MP178

‘Removing DSP validation against the SMI join status for SR8.8.x’

Modification Report

9 May 2023

Process diagrams for the Unjoin commands are shown following.

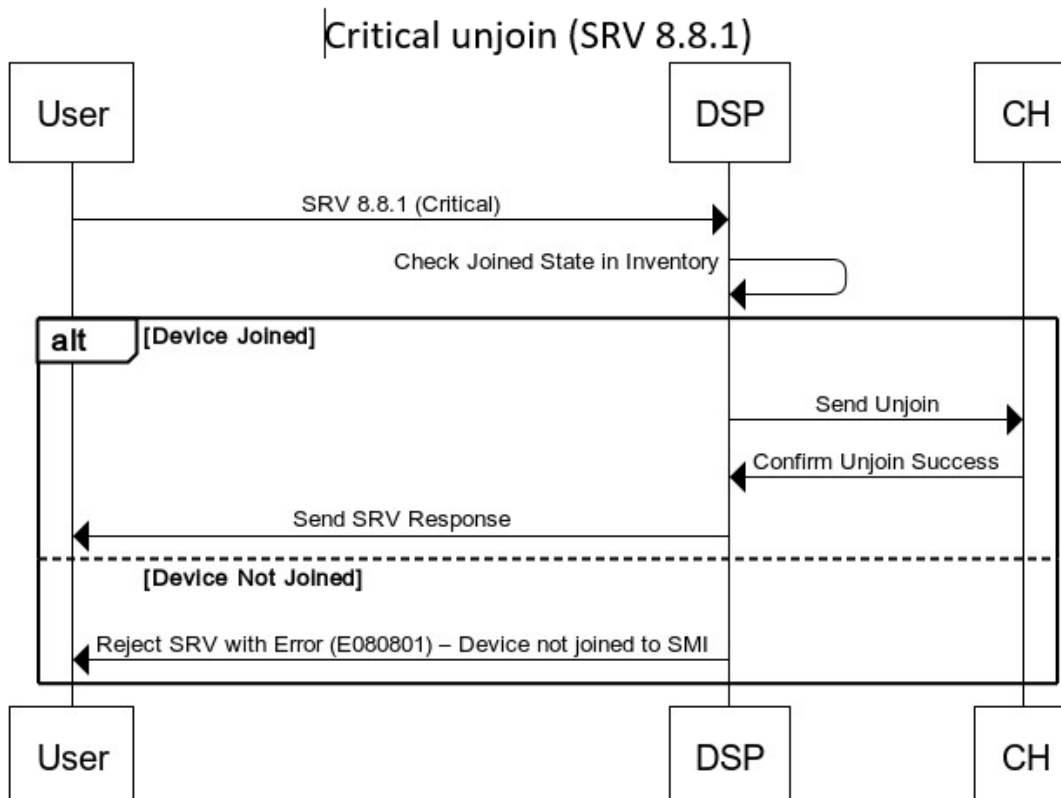
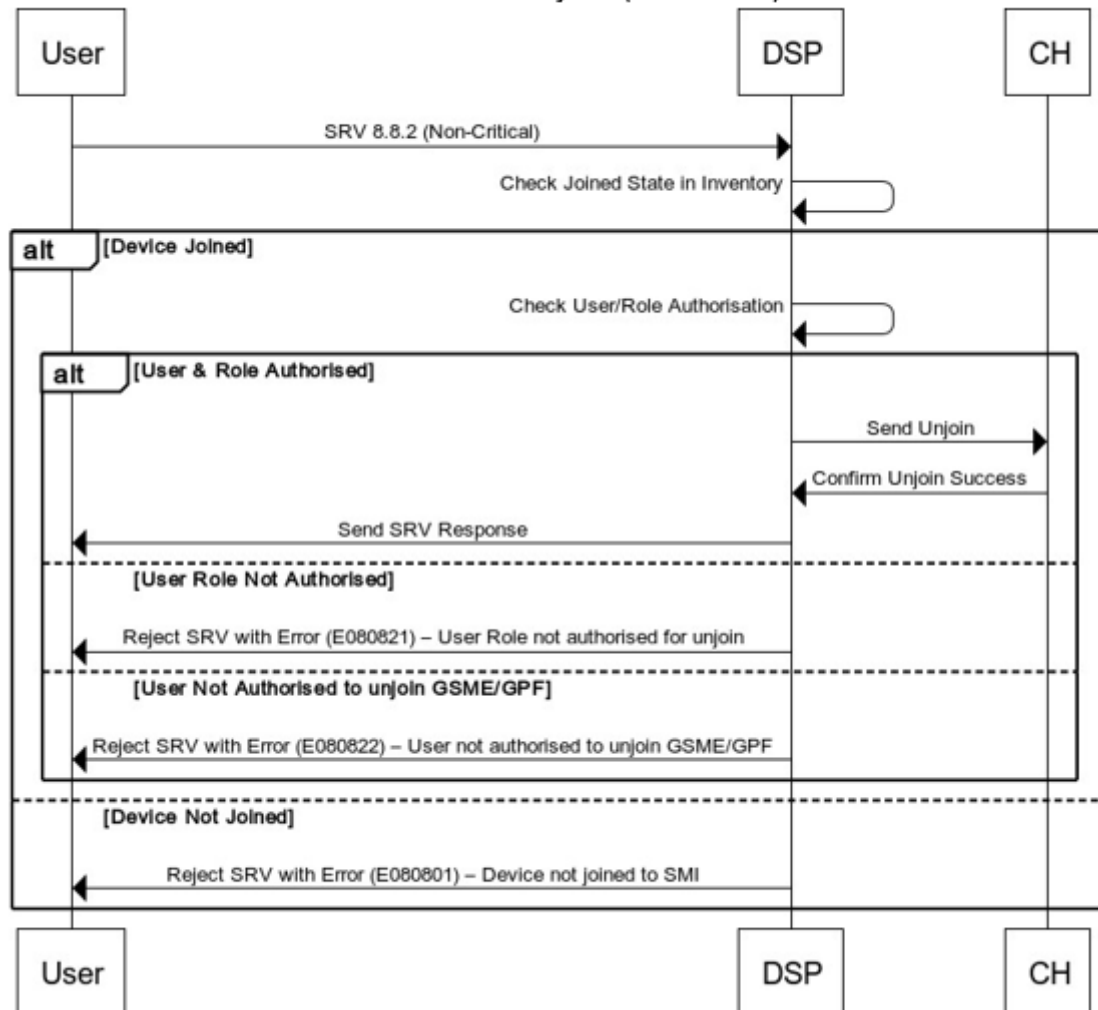
Requirement 1: Remove the DSP validation associated with the unjoin commands (SRV8.8.1 and SRV8.8.2) resulting in Response Code E080801

Use cases have arisen that would benefit from removing the DSP validation process, which is currently associated with the Unjoin command. The current manual workaround is costly and time consuming to update the SMI to reflect the correct status for each Device. This has led to unsatisfactory Consumer experience and costs.

DSP will modify the validation of SRV 8.8.1 Unjoin Service (Critical) and SRV 8.8.2 Unjoin Service (Non-Critical) to remove the check that the OtherDeviceID from the SRV is flagged in the SMI as being joined to the target Device of the SRV.

Remove the check that the OtherDeviceID from the SRV is already joined to the target Device of the SRV (subject to feature switch).

On processing a successful Unjoin response from the device, the Join record in the database is removed. This removal will be amended to tolerate no record being present to be removed.

Process flow diagrams

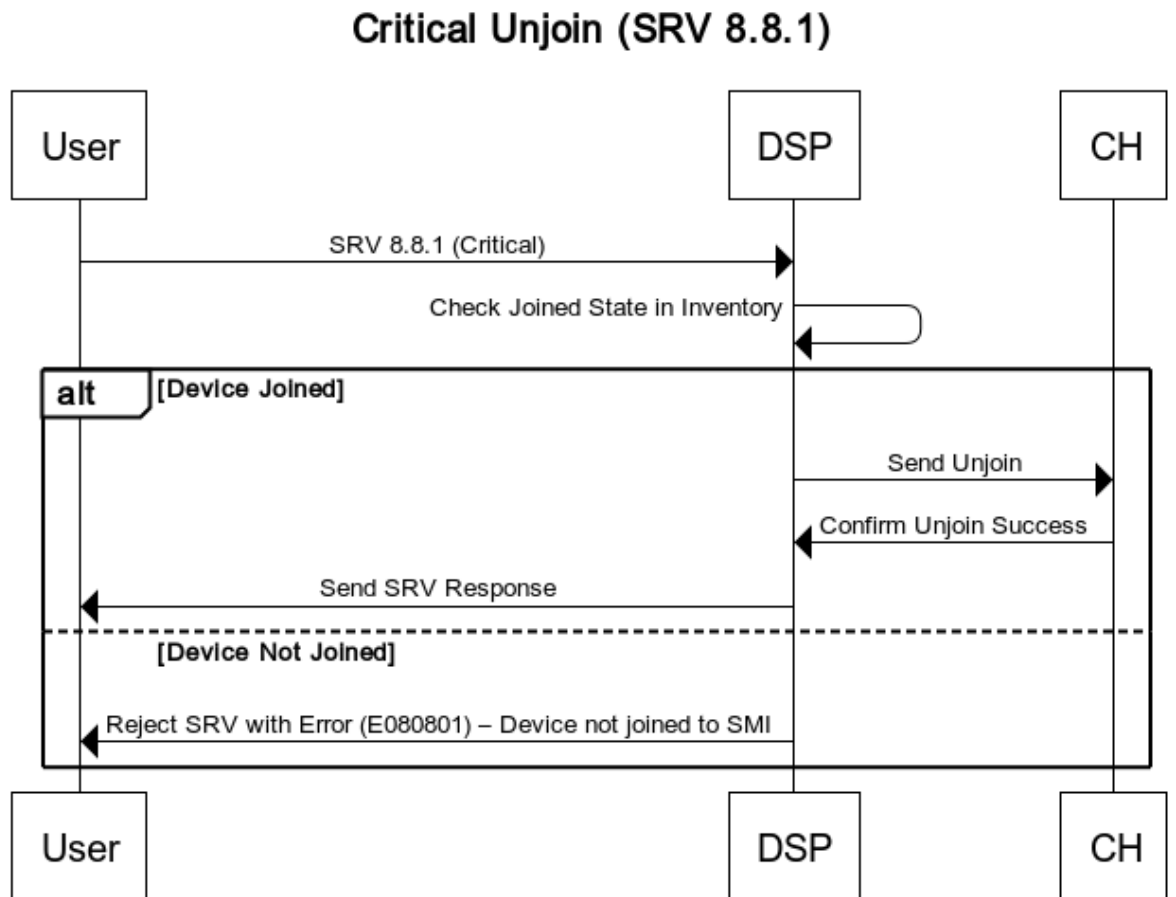
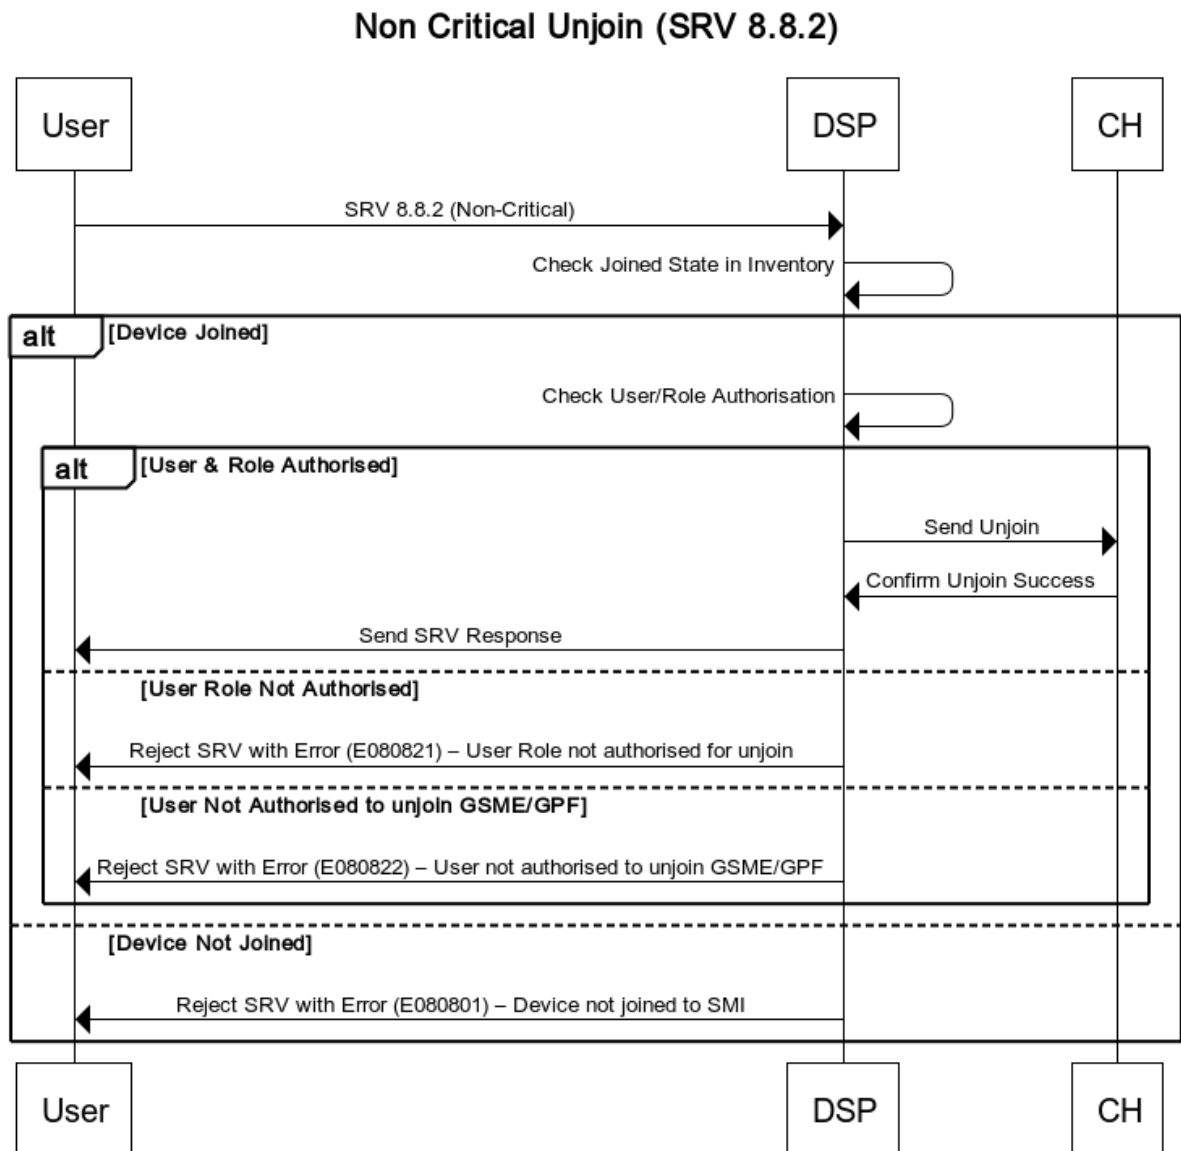
The Proposed Solution was presented to the TABASC, where there was concern about removal of the Response Code E080801 and the impacts on Parties Business Processes. SECAS provided two Process diagrams (refer to Annex D) which were circulated to the TABASC and Parties. The TABASC subsequently advised it does not see any impacts arising from the removal of the Response Code E080801. The Working Group and the Proposer decided to keep the response code but amend to clarify it's no longer used, as this was a cheaper option and would not impact DUIS Schema.
